RESOURCE MANAGEMENT ROUTING SHEET

Project Name: Somerset Estates Phase II At Kings Ridge

RE: **SOMERSET PHASE II & III (FBA #941216.114) - APPLICATION #4-069-19411-10**

# EXISTING NODAL MAP

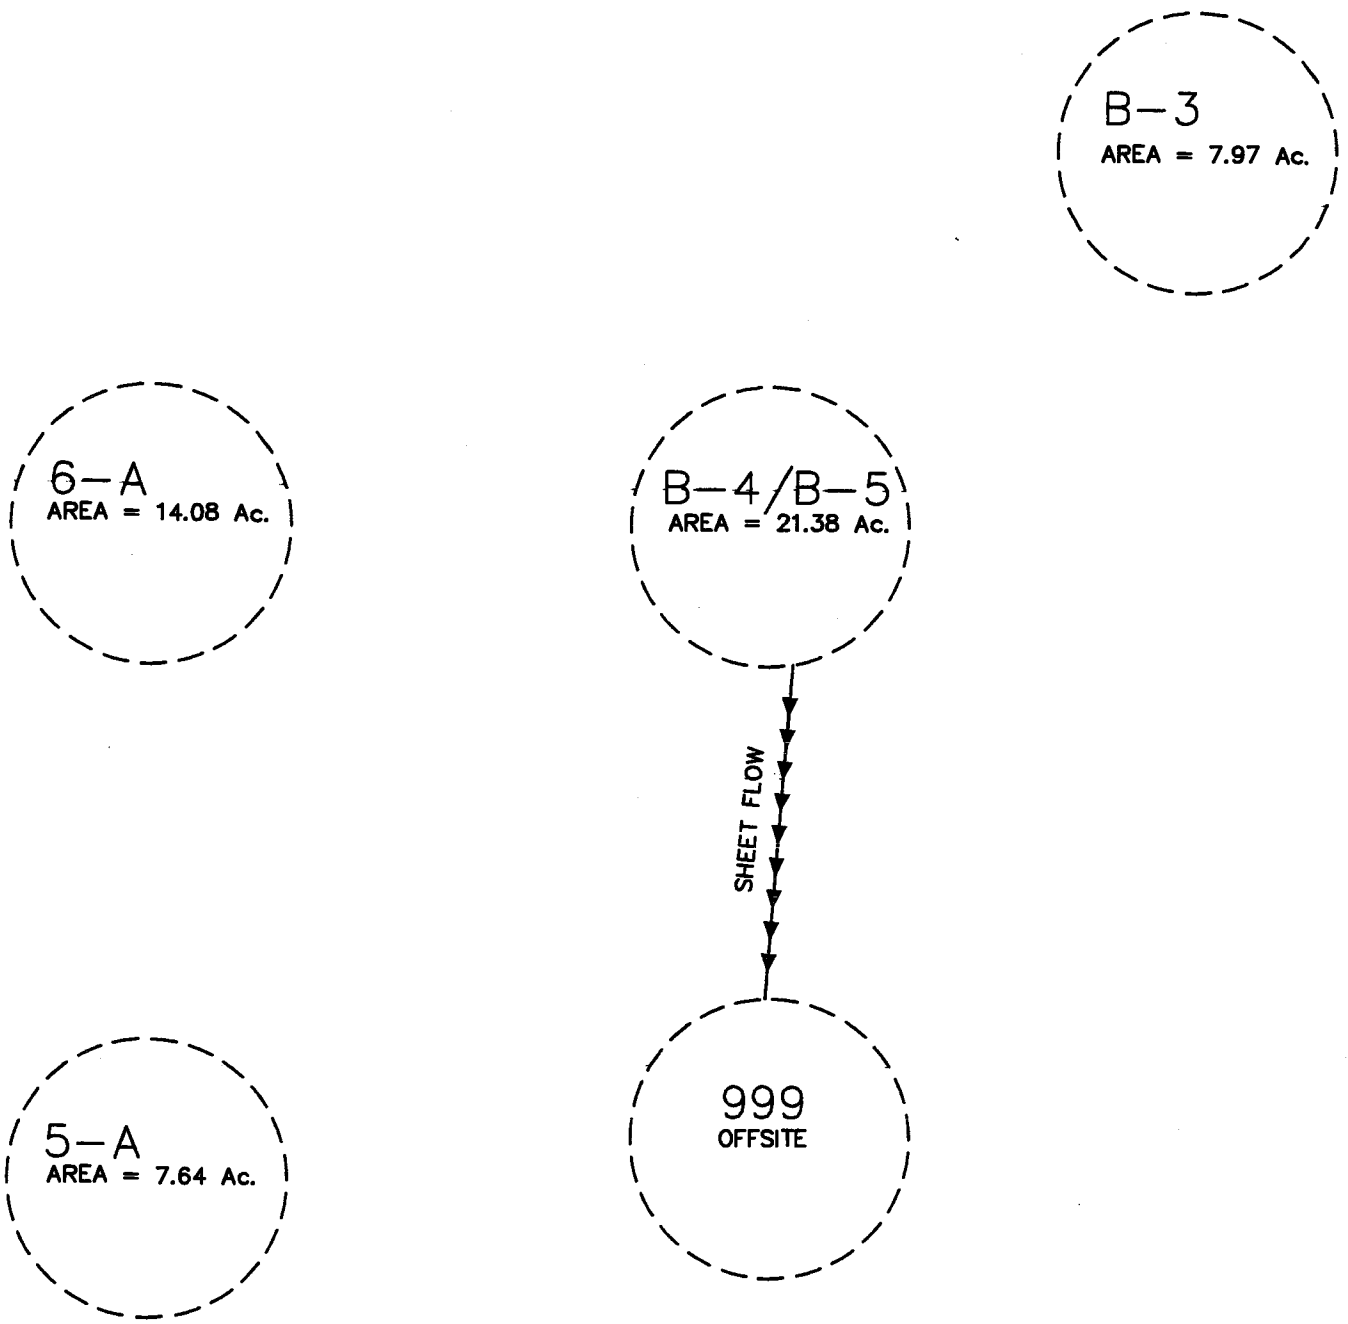
3. Please provide a pre-development and a post development nodal diagram in a drainage basin map for the proposed project site. The requested nodal diagram should include all reaches and nodes clearly identified. Submit any revised plans and calculations, as applicable.

**See attached nodal diagram, basin B-4 flows into basin 6-A via storm pipe. Basin 6-A is a landlocked system and is designed for 25 yr.-96 hour stormwater event. Basin B-5 flows into basin 5-A via storm pipe. Basin 5A also is in a landlocked system and is designed for the 25 yr - 96 hr storm event. There is no discharge from either basin during the 25 yr-96 hr. storm event .**
